May 15, 2019
BOARD OF COUNTY COMMISSIONERS
ORANGE COUNTY, FLORIDA

Y19-751-CH/Addendum #4

**CONNECTOR ROAD FROM HILTON DRIVEWAY TO APOPKA VINELAND ROAD
INTERSECTION IMPROVEMENTS**

Bid Opening Date: May 30, 2019

Professional Engineer Seal for Jonathan Allen Martin, No. 54055, State of Florida. Includes text: ORANGE COUNTY DEPARTMENT OF PUBLIC WORKS, SUMMARY OF DRAINAGE STRUCTURES, SHEET NO. 18, and a date stamp APR 30 2019.

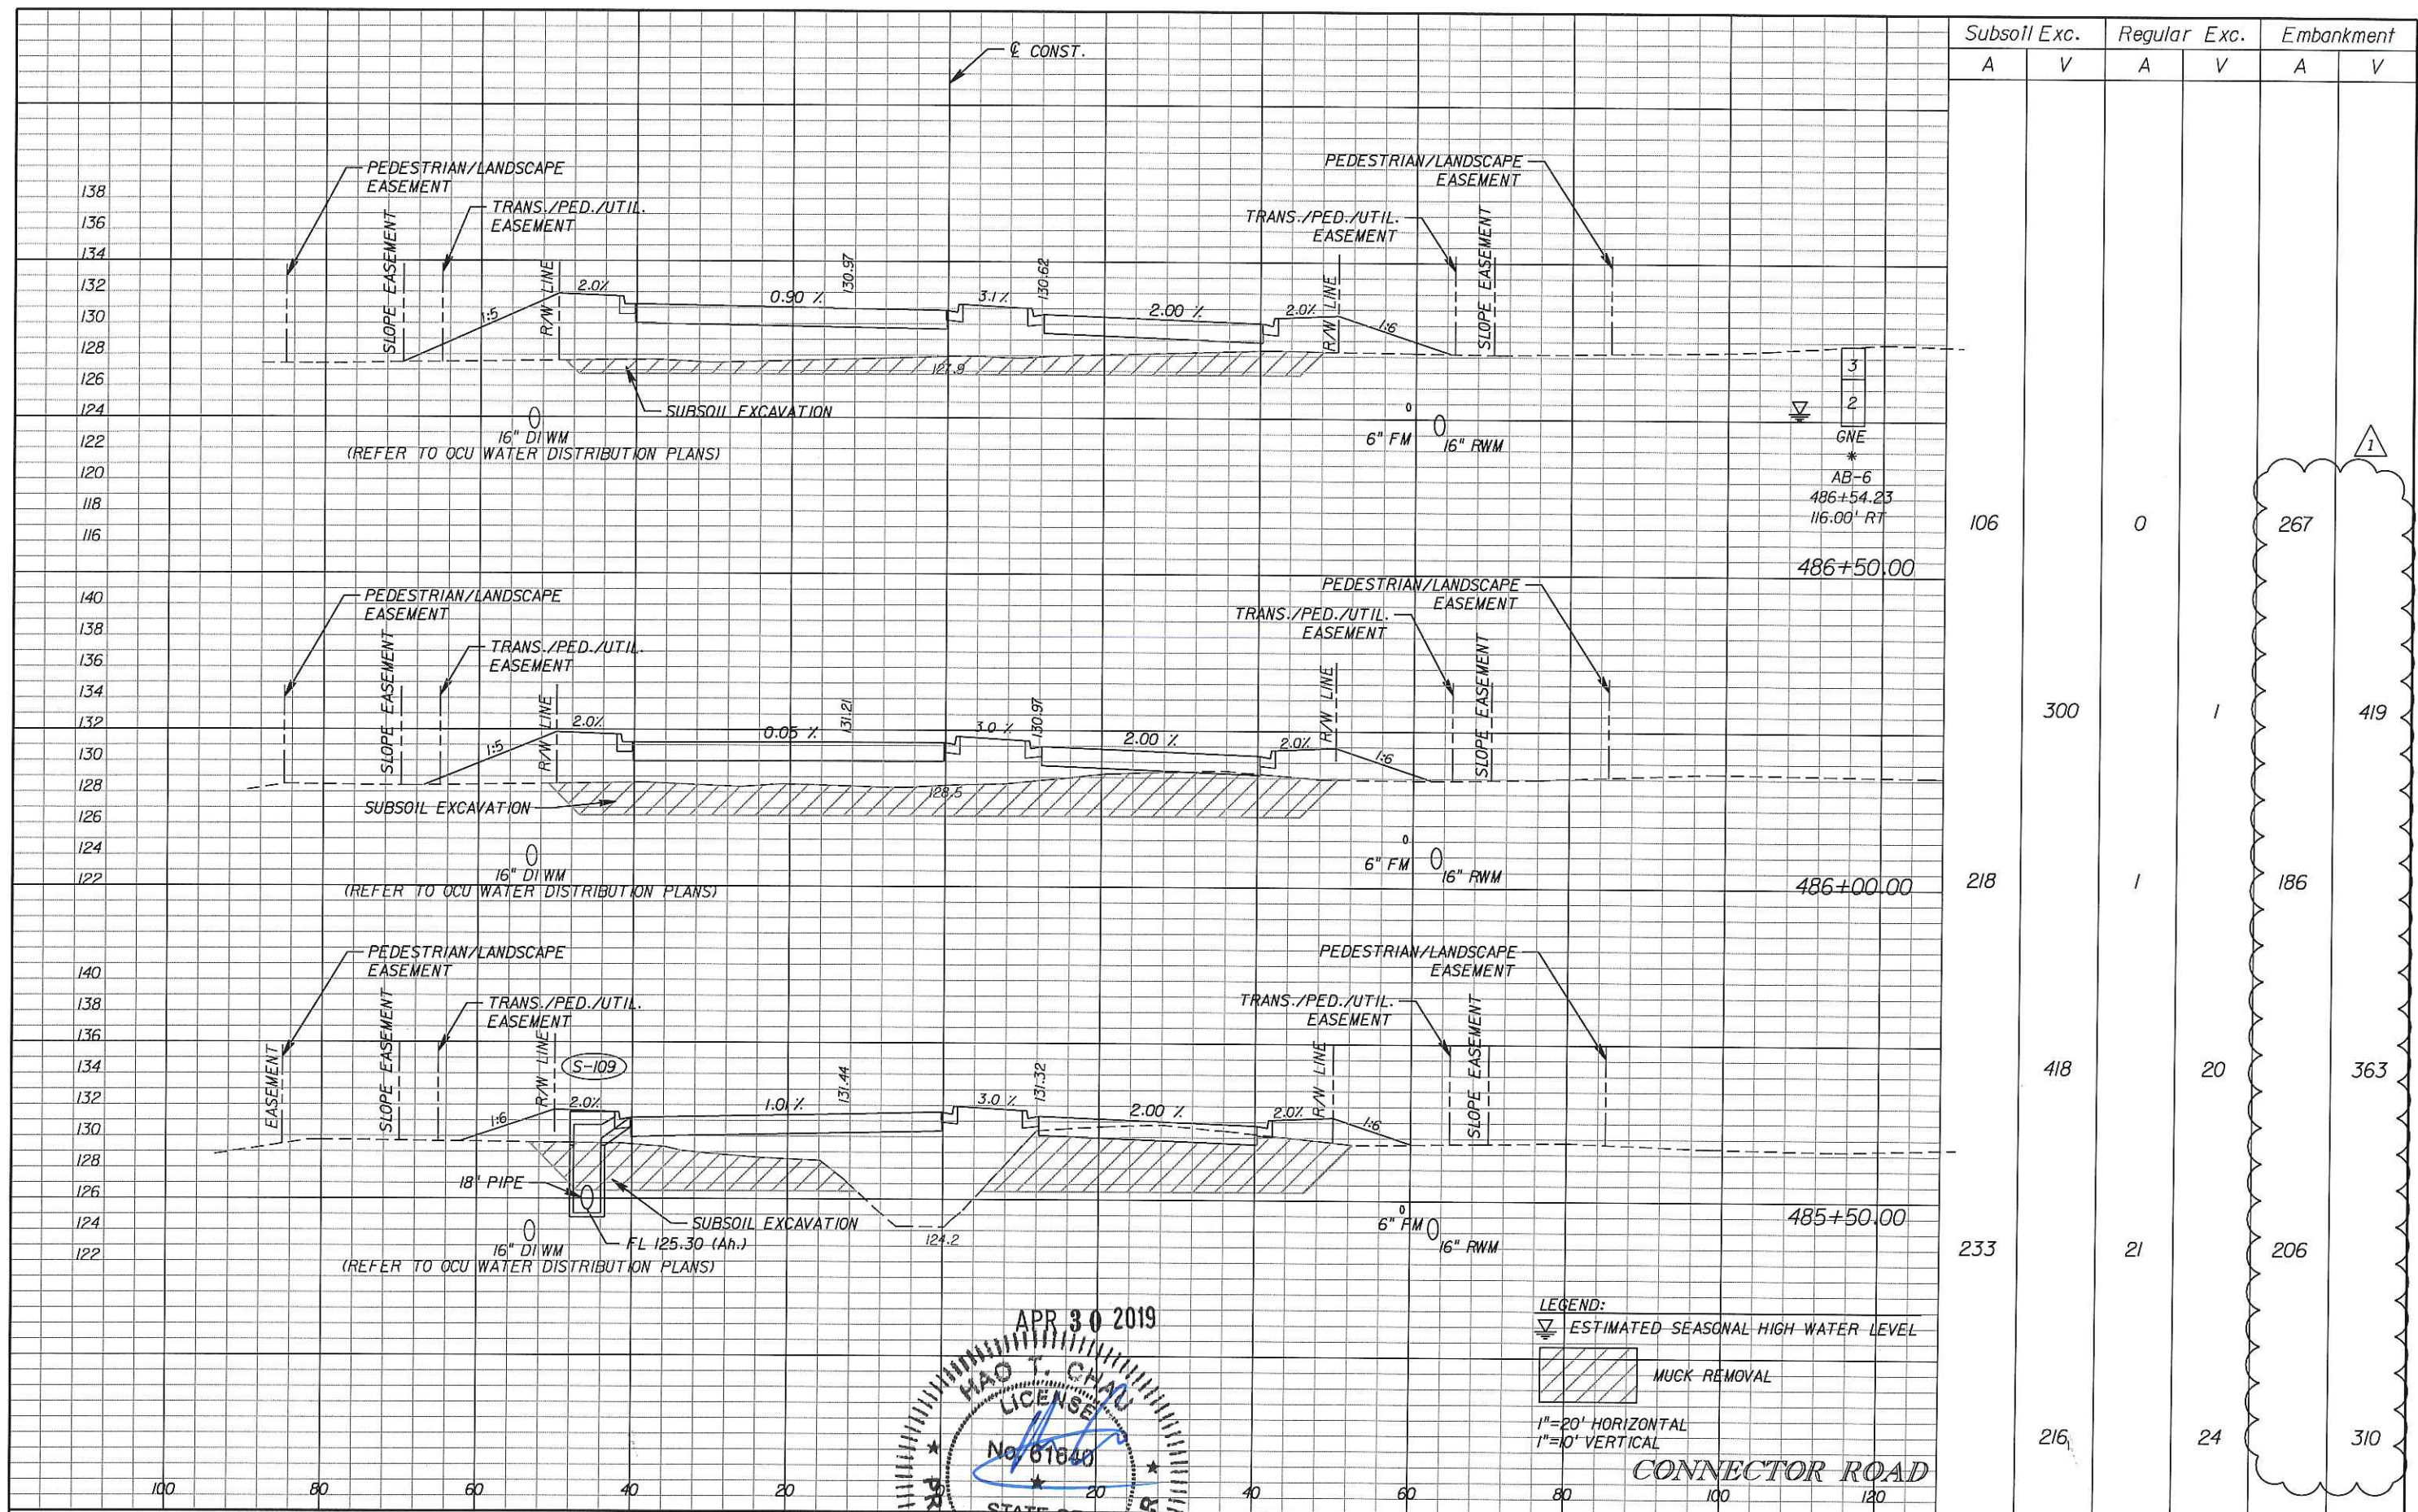
9. **Question:** Structures S-406A and S-124 are both >10', bid form only calls for 1 EA please review accordingly.

REVISIONS table with columns: DATE, BY, DESCRIPTION, DATE, BY, DESCRIPTION. Includes revision 1: REVISED S-406A.

Response: Agree, the bid item 425-1-412, INLET (CURB TYPE J-1) (>10') quantity should be 2 EA. The 425-1-411, INLET (CURB TYPE J-1) (<10') should be 11 EA. Plans and schedule of prices have been revised accordingly. The updated schedule of prices is attached in this Addendum. The updated plans are located at the following FTP site:

SHEET NO.
 58

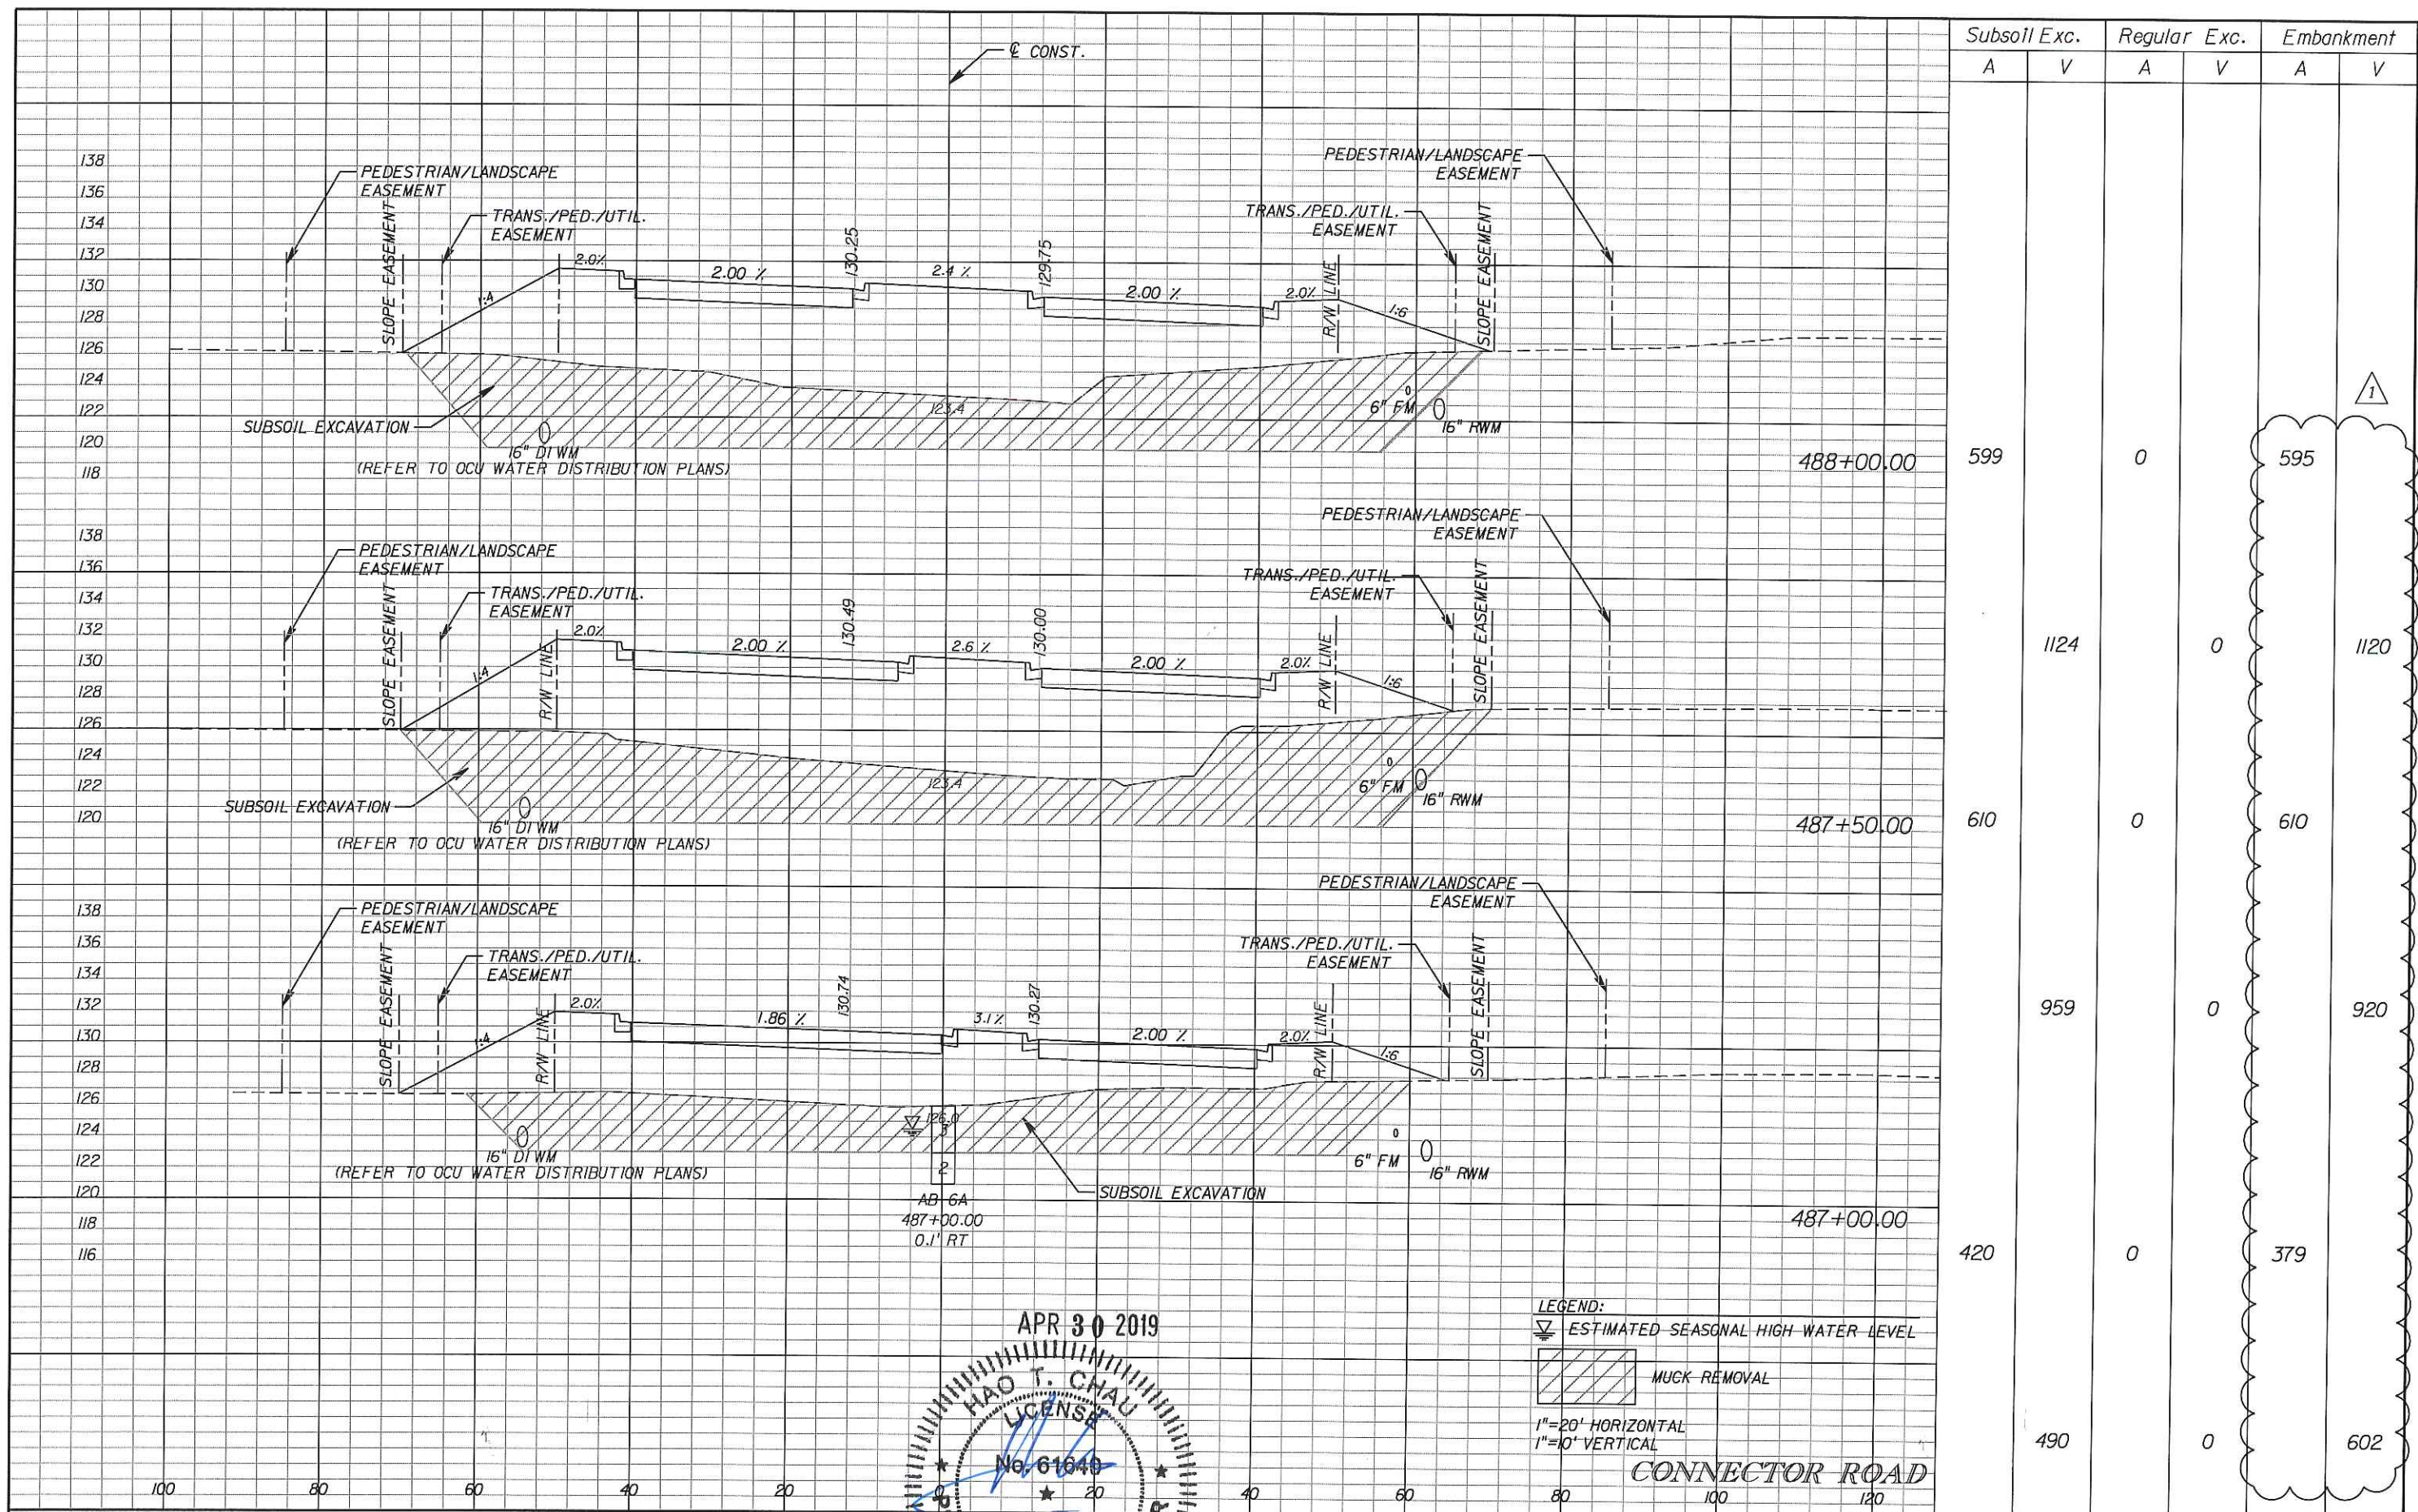
DATE	BY	DESCRIPTION	DATE	BY	DESCRIPTION
04/30/19		1 REVISED EMBANKMENT QUANTITIES
